Request for Proposal KUAT Television Transmitter Replacement

ADDENDUM #1

**Sealed RFP # L192303
Due on August 30, 2022 no later than 2:00 PM, MST**

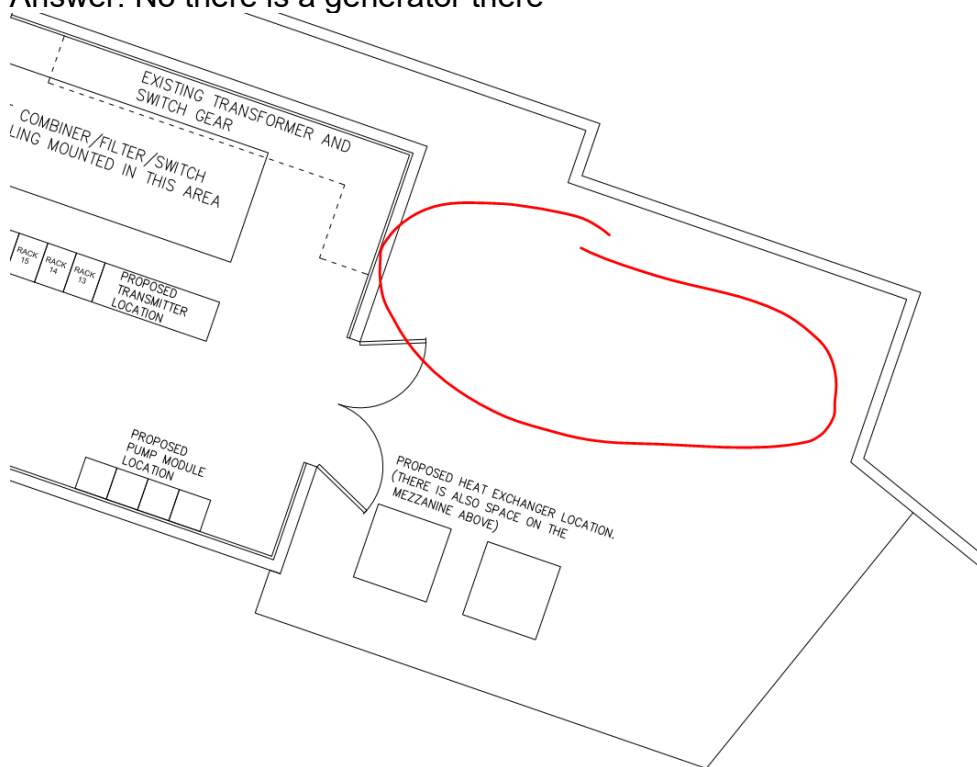
29. What is the height from proposed HEX pad to Mezzanine above? (Vertical Clearance for Heat exchangers)

Answer: nine feet eight inches lower level and eight feet six inches upper level. On upper level the HVAC remains and the heat exchanger will be removed. (See photos)

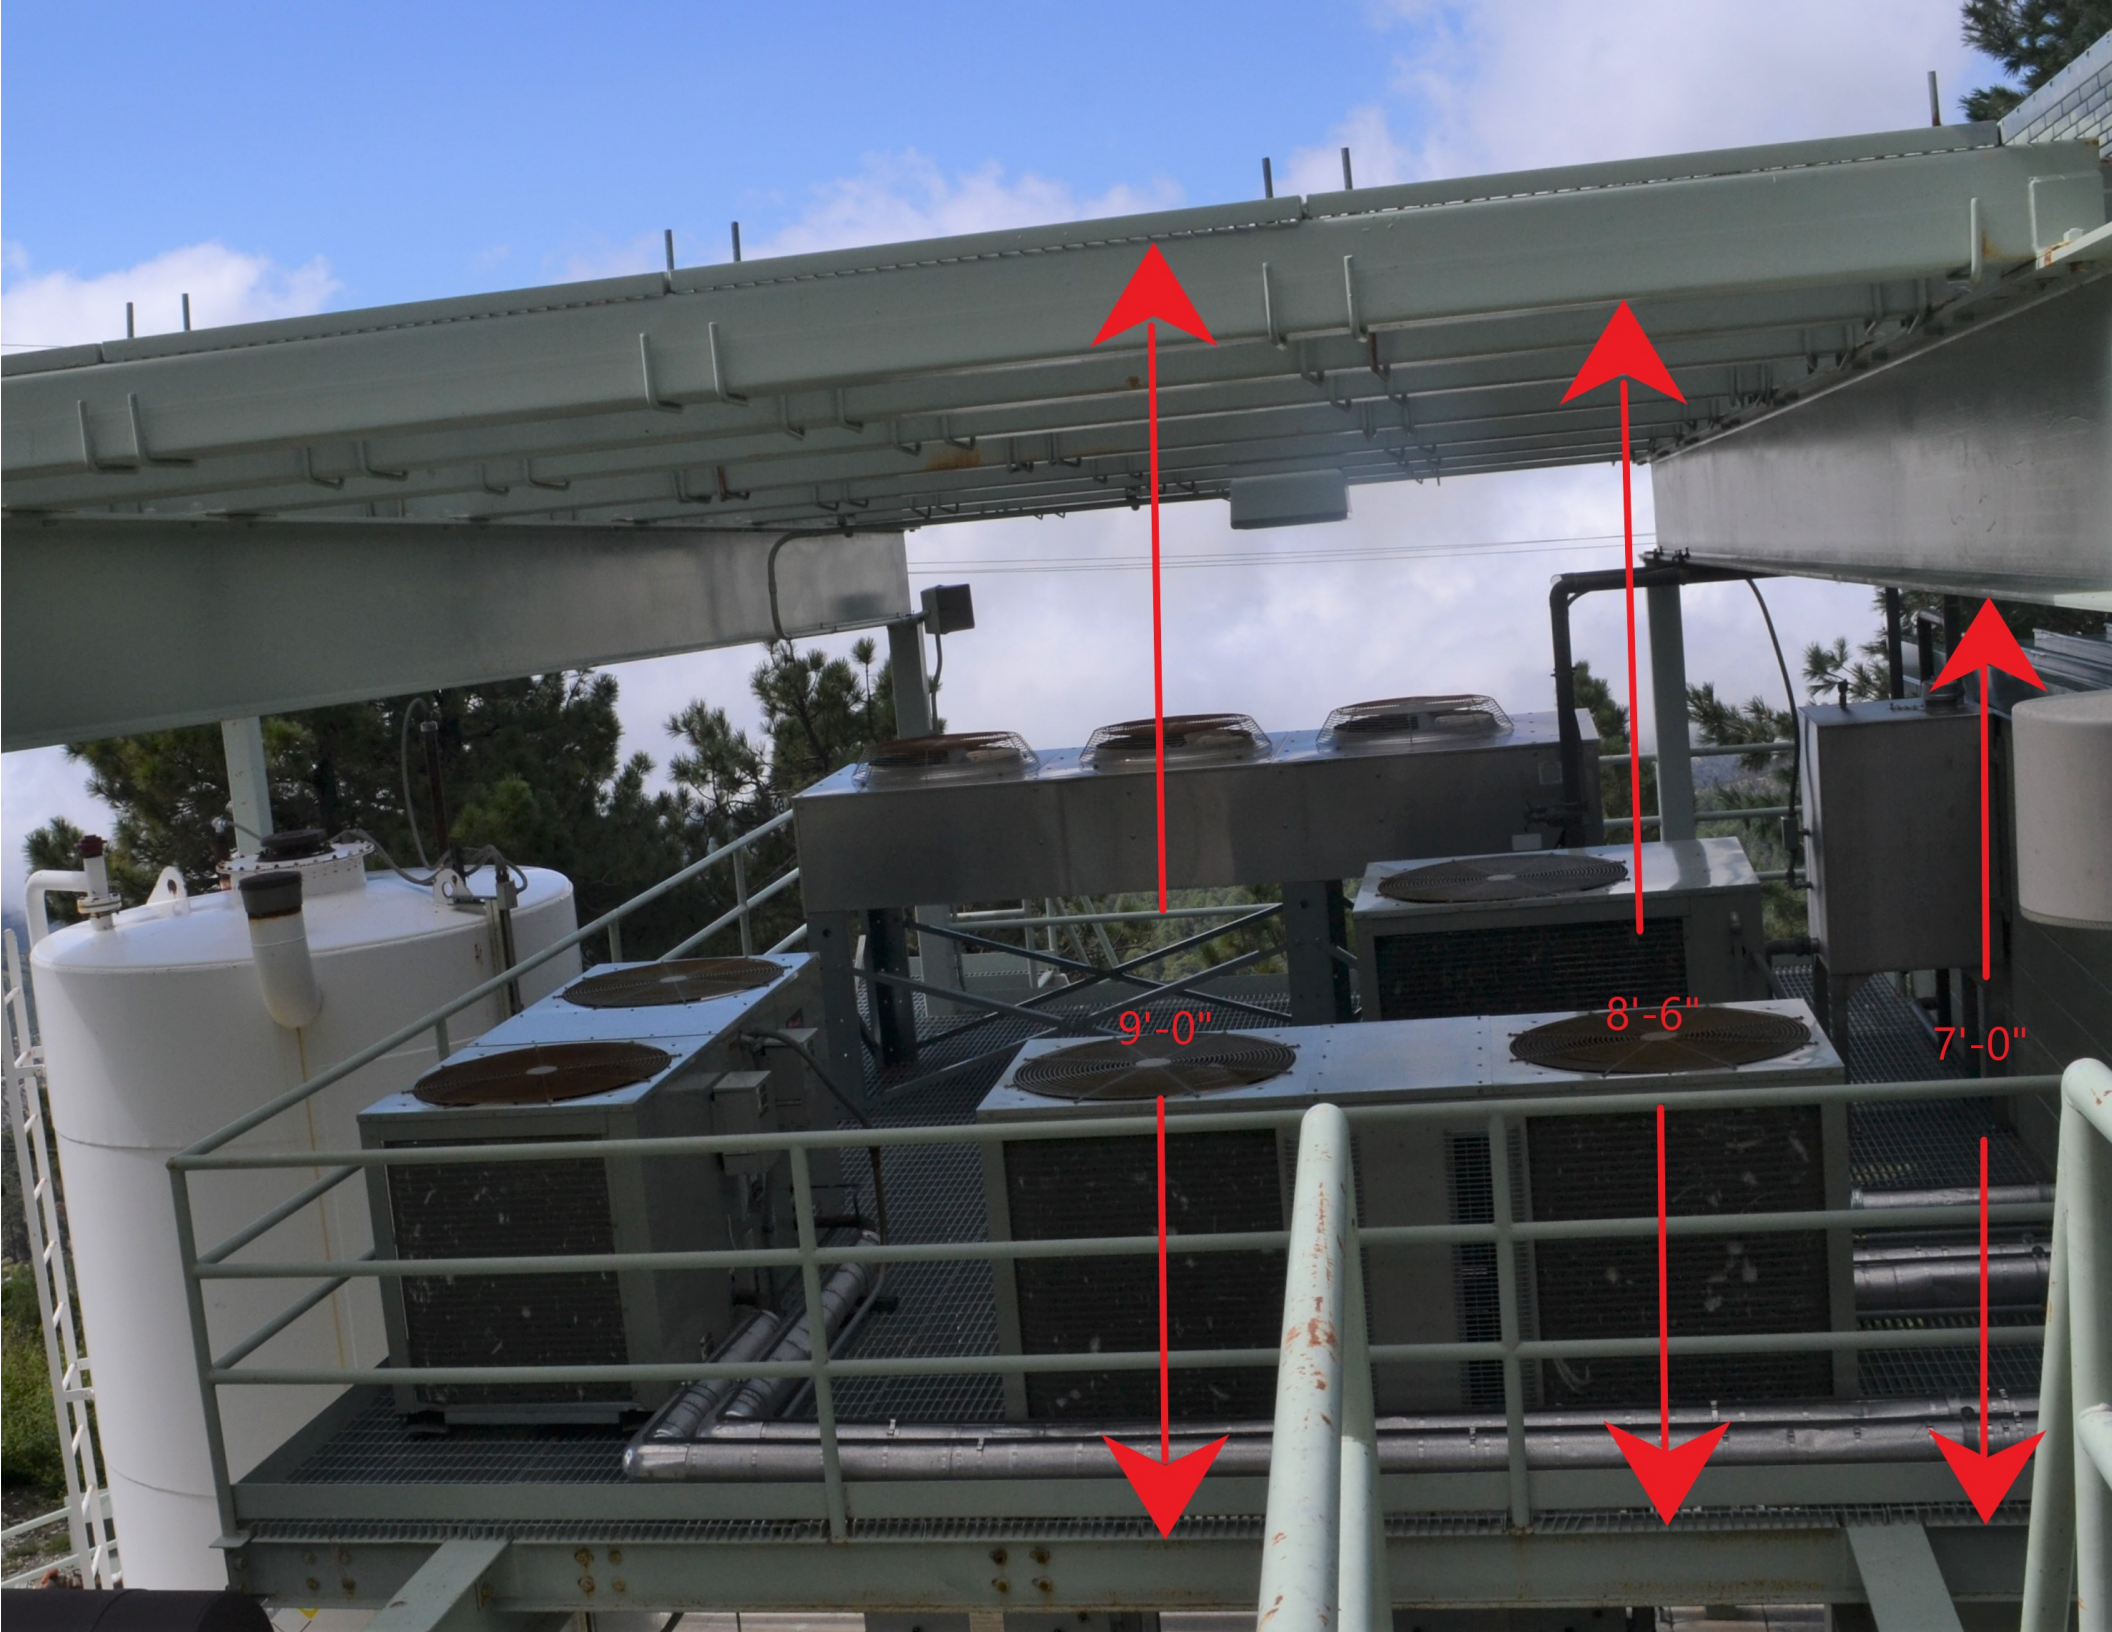
31. Is the space circled in red available for Heat exchanger units? It was hard to tell what is in that space or if it is empty from the pictures on the call we had.

Answer: No there is a generator there
